STAFF RECOMMENDATION

1009 Acklen Avenue

October 19, 2016

Application: New construction – Outbuilding; Setback determination

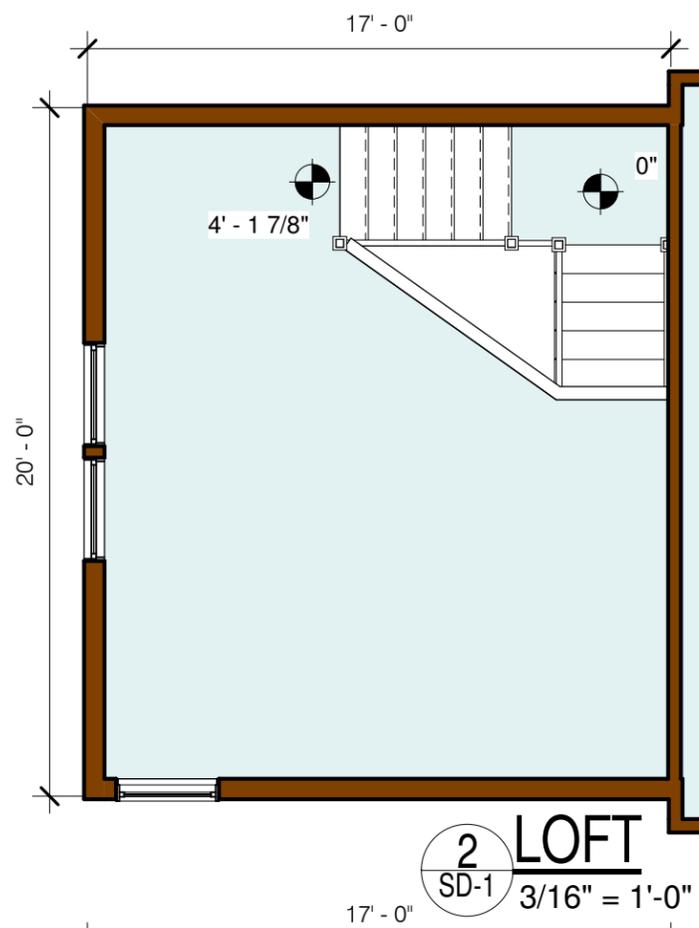
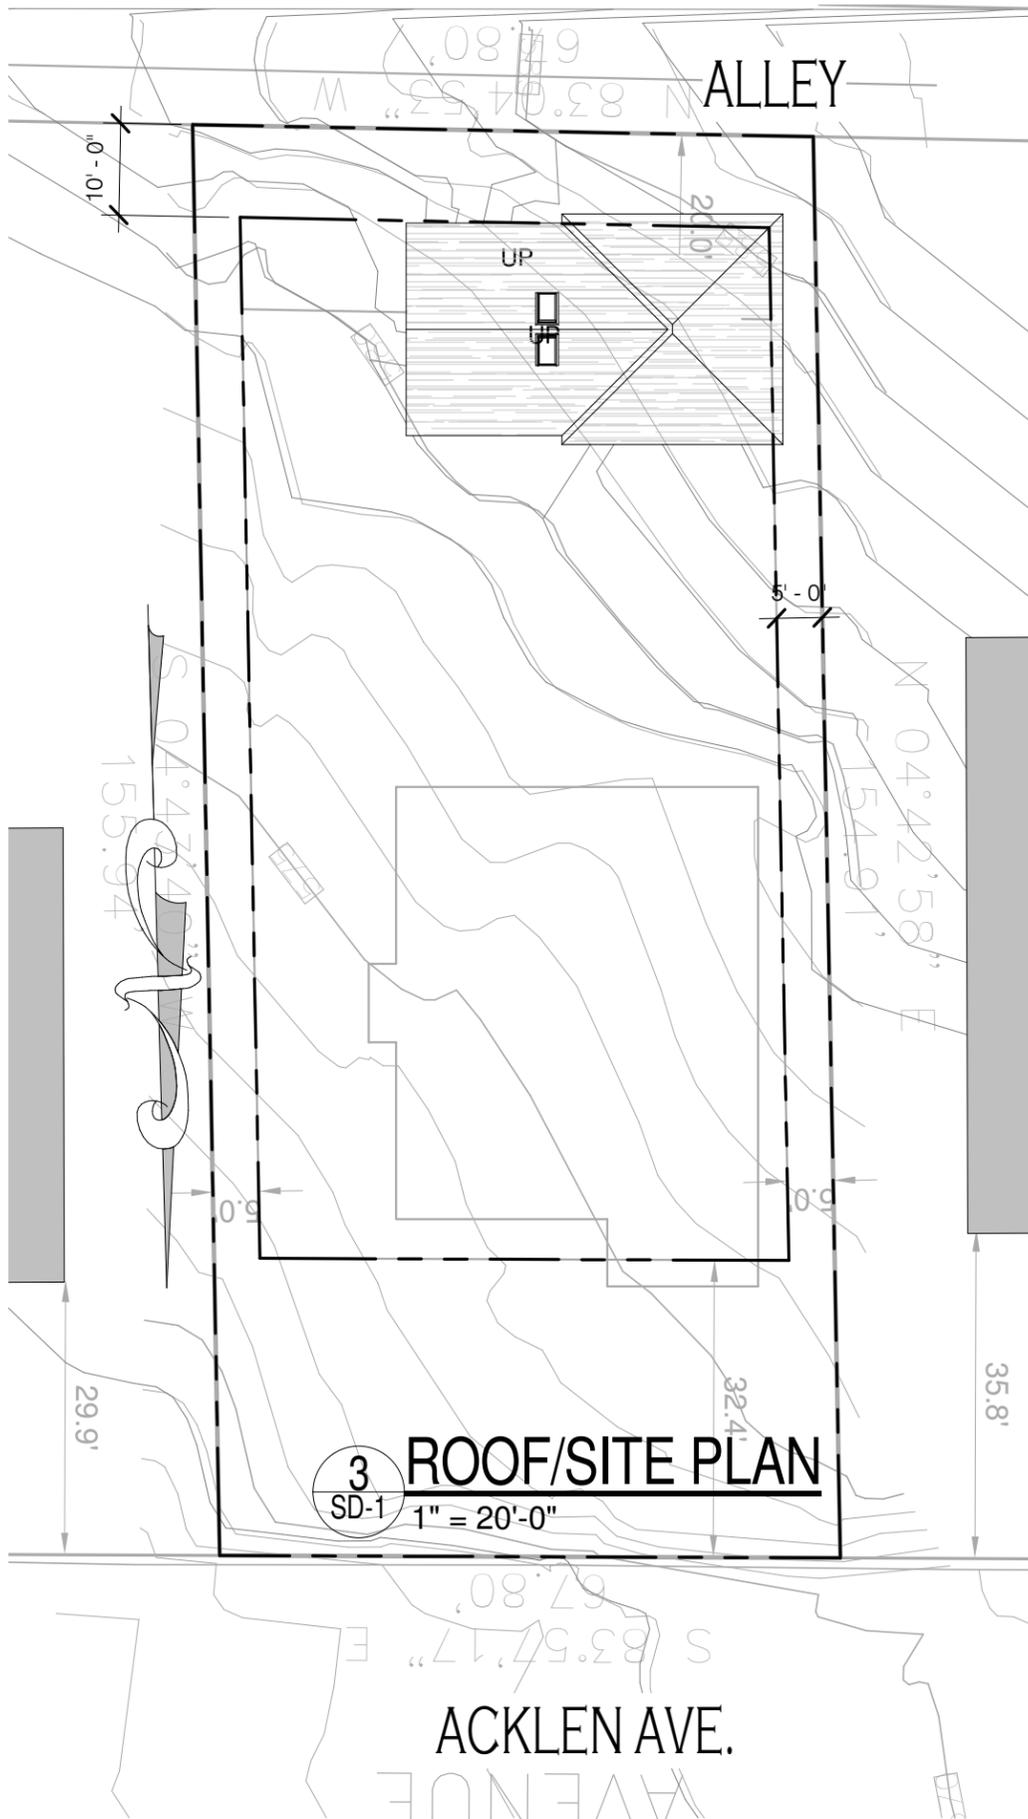
Site Planning & Setbacks: The new outbuilding will be located behind the principal building, with vehicle access coming off of the alley. This location is typical of outbuildings historically, but the proposal will require a rear setback determination.

The base zoning would require the proposed outbuilding to have a twenty foot (20') rear setback and five foot (5') side setbacks. The proposal meets the side setback requirements but the applicant requests a rear setback determination for the building to be located ten feet (10') from the rear of the property. The Commission can approve shorter setbacks if doing so would be more appropriate with the historic context. Rear setback determinations have been approved on several occasions, and Staff finds that the shorter setback would be appropriate in this location.

Staff finds the proposed setbacks to be appropriate and that the project meets section III.H.6 of the design guidelines.

ELEVATIONS
SD-2
PROJECT 1631B
DATE 09.22.16

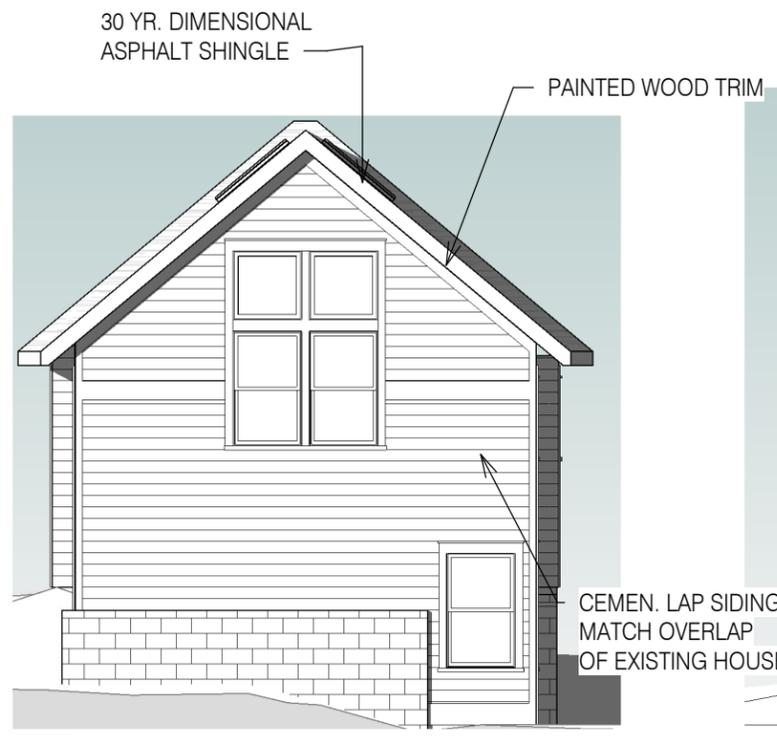
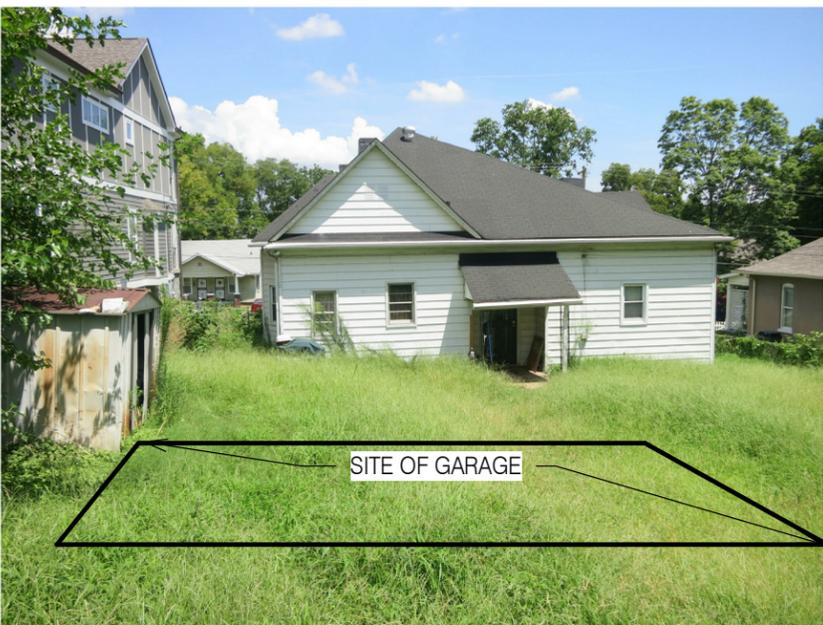
Design Standards: The building will have two components: a one-story hipped-roof component and a gabled wing projecting to the side. The gabled section will be shorter than the hipped section, but because of a substantial drop in grade it will gain a partial basement level. Staff does not consider this to be a two-story building because the additional level is below the primary grade. The roof forms and overall character of the building will complement the principal structure.

The roof of the building will have a hipped component with a side projecting gable. The form and pitch of the roof are typical for outbuildings in the surrounding area and are compatible with the principal building, therefore Staff finds the project to meet section III.H.3 of the design guidelines.

With the staff’s final approval of the windows and doors and any other materials not yet specified, staff finds that the known materials meet sections III.H.1, III.H.4 and III.H.5 of the design guidelines.

1. The window and door selections shall be approved by MHZC Staff prior to purchase and installation.
